PRAIRIE RIDGE ESTATES,
SEDGWICK COUNTY, KANSAS

Re: S/D 98-53 -- Final Plat of PRAIRIE RIDGE ESTATES ADDITION

STAFF REPORT

CASE NUMBER: S/D 98-53 - PRAIRIE RIDGE ESTATES ADDITION

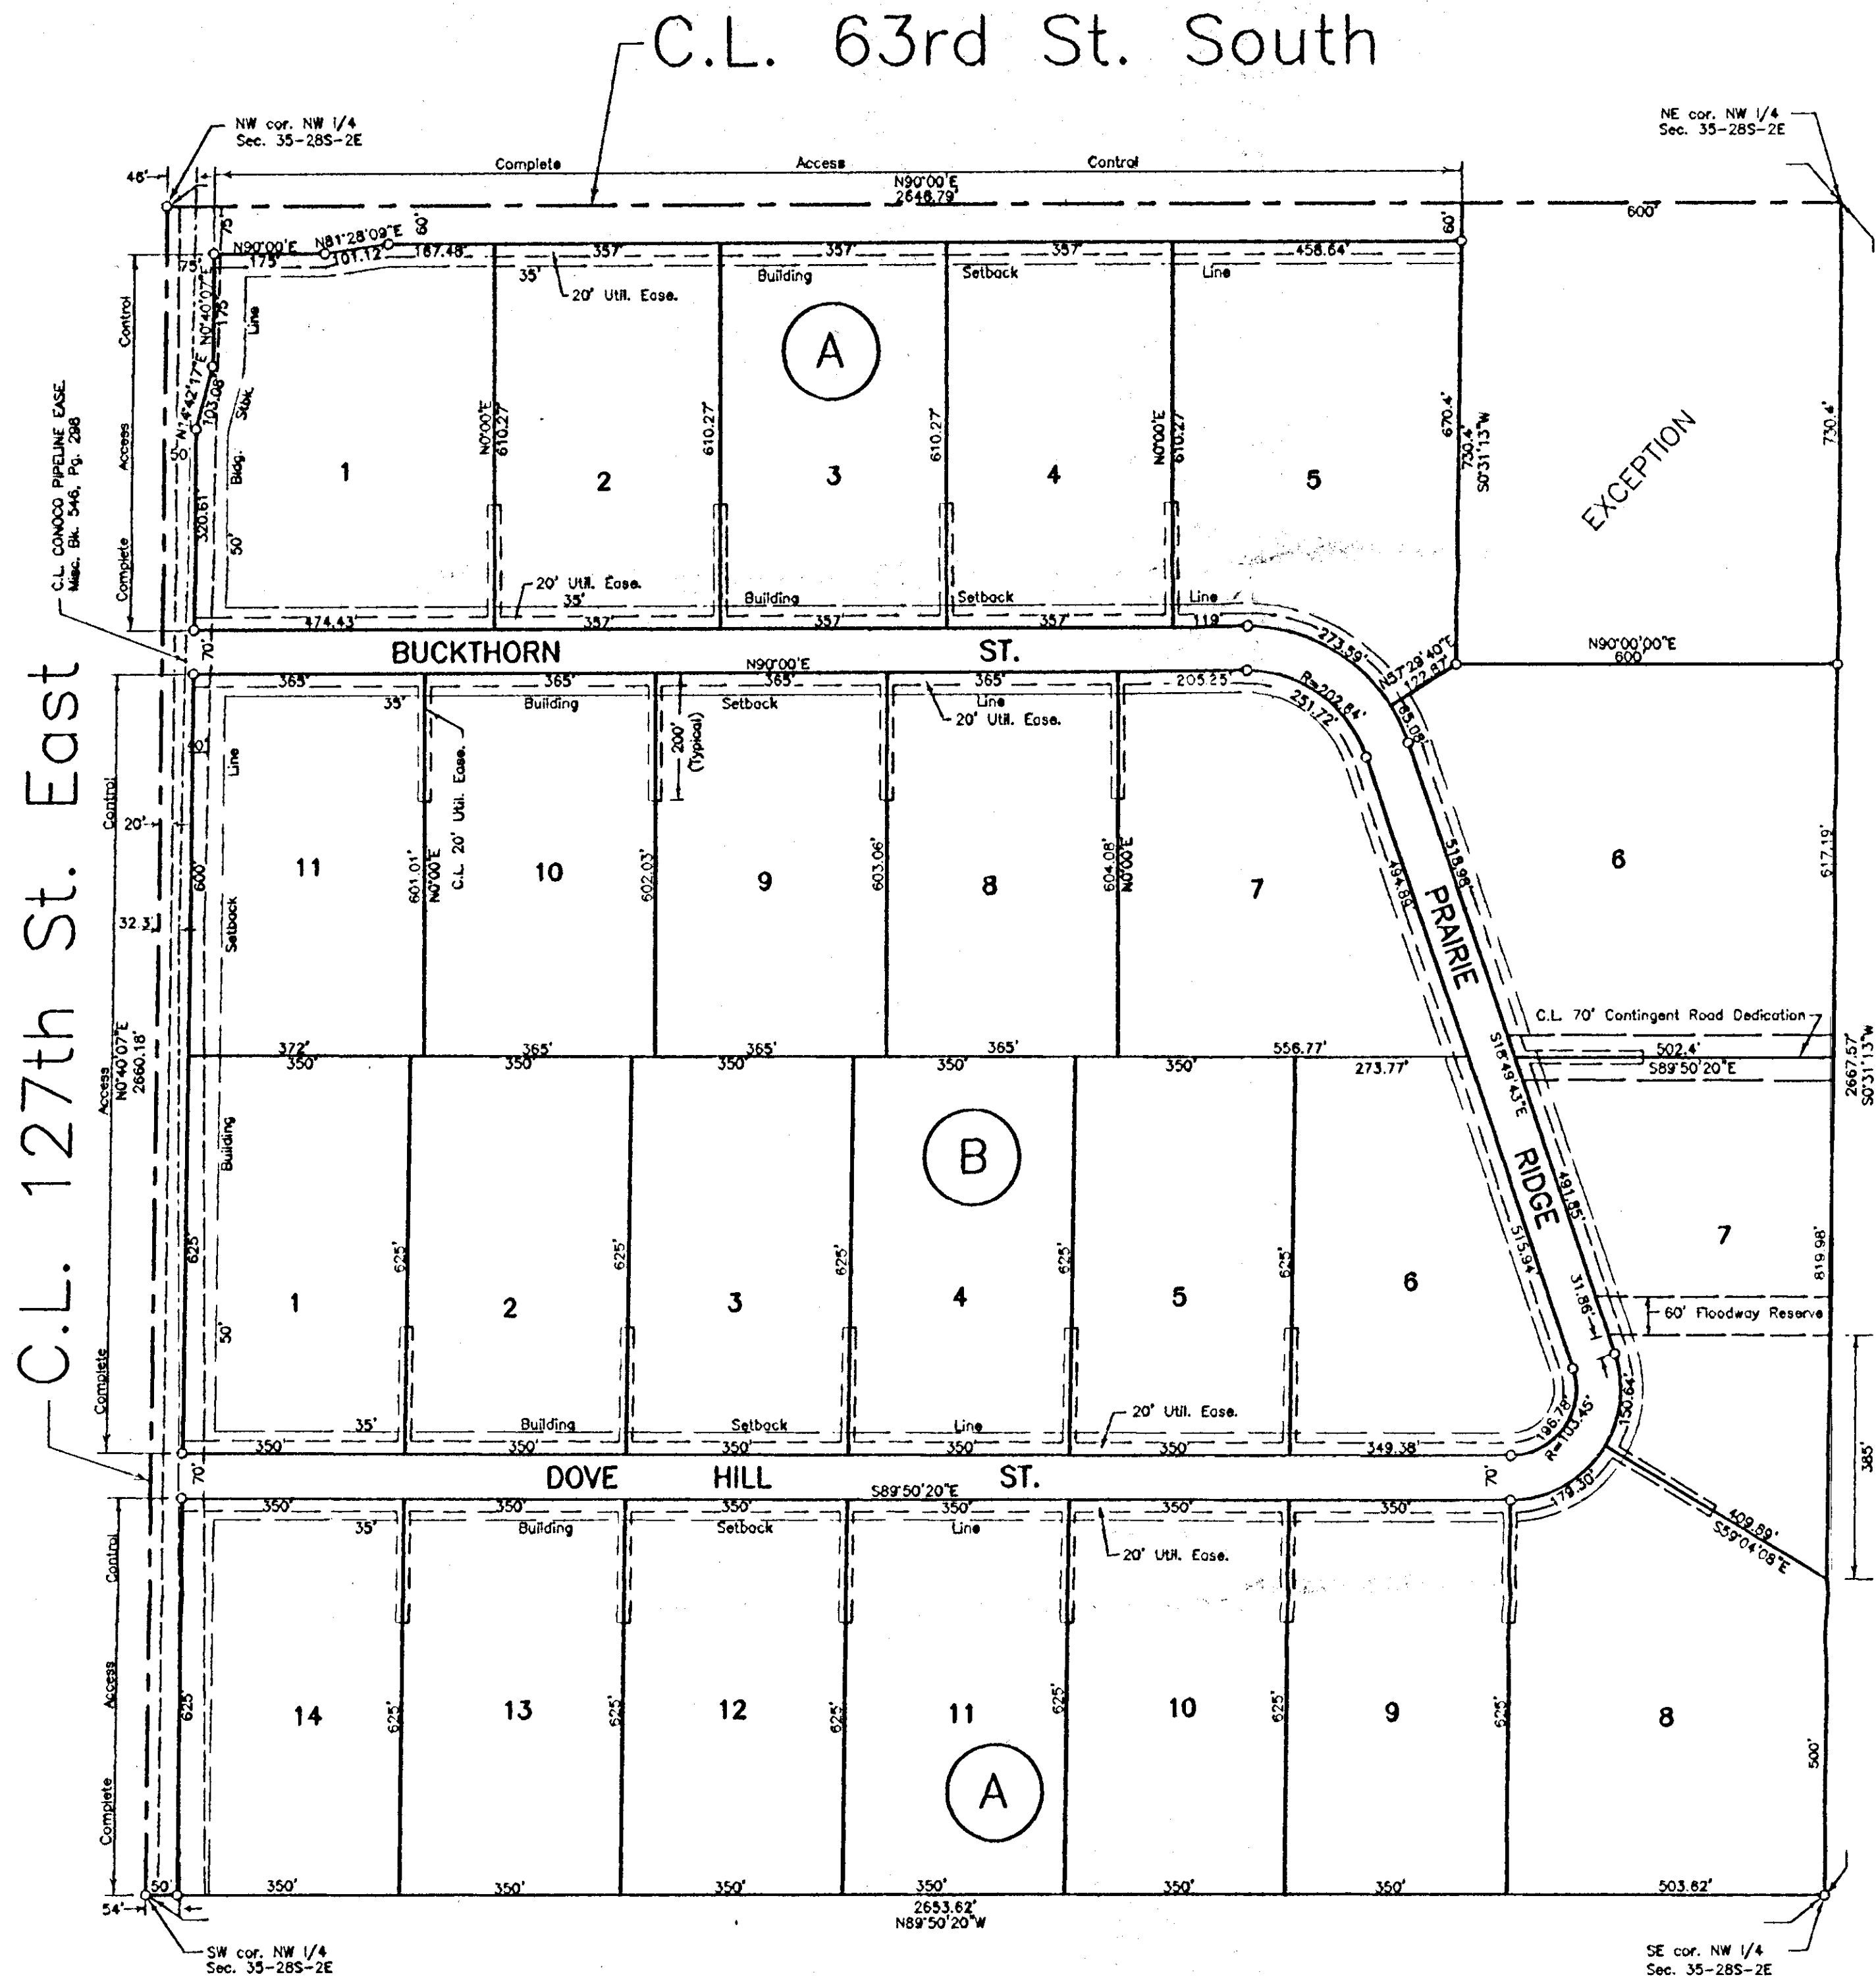
- D. *County Engineering* needs to comment on the status of the applicant's drainage plan. *Floodway reserves will need to be platted to cover cross-lot drainage. County Engineering requests the floodway reserve in Lot 7 to be increased in width from 40 feet to 60 feet.*

- E. The applicant shall guarantee the installation of the proposed interior streets to the 32-ft sand road standard.
- F. Complete access control shall be dedicated along the site's frontage to 63rd St. South and 127th St. East. On the final plat, the dedication of access controls shall be referenced in the plat's text.

- G. County Fire needs to comment on the acceptability of the plat's street names. *The street names are acceptable.*
- H. Contingent right-of-way dedications extending to the south and east line of the plat is recommended in order to provide potential street connections. These dedications shall be referenced in the plat's text as being effective upon the platting of any adjacent subdivision having a street connecting thereto. *Applicant explained the existence of 10-acre developed lots to the south; but agreed to plat a contingent right-of-way dedication to the east.*

- I. County Engineering needs to comment on the need for improvements to perimeter streets or additional right-of-way. *An additional 10 feet of half street right-of-way needs to be dedicated along the north line of the plat.*

- L. County Engineering should comment on the length of the cul-de-sac (2,100 ft.) which exceeds the 1,200 ft. standard. *County Engineering recommends that the southern cul-de-sac be looped northward and connected to the northern street.*

The requested access controls have been depicted on the final plat.

The Subdivision Committee required the platting of the contingent right-of-way dedication to the east on the final tracing.

The requested 10-feet of half-street right-of-way has been denoted on the final plat.

The requested loop street has been denoted on the final plat.
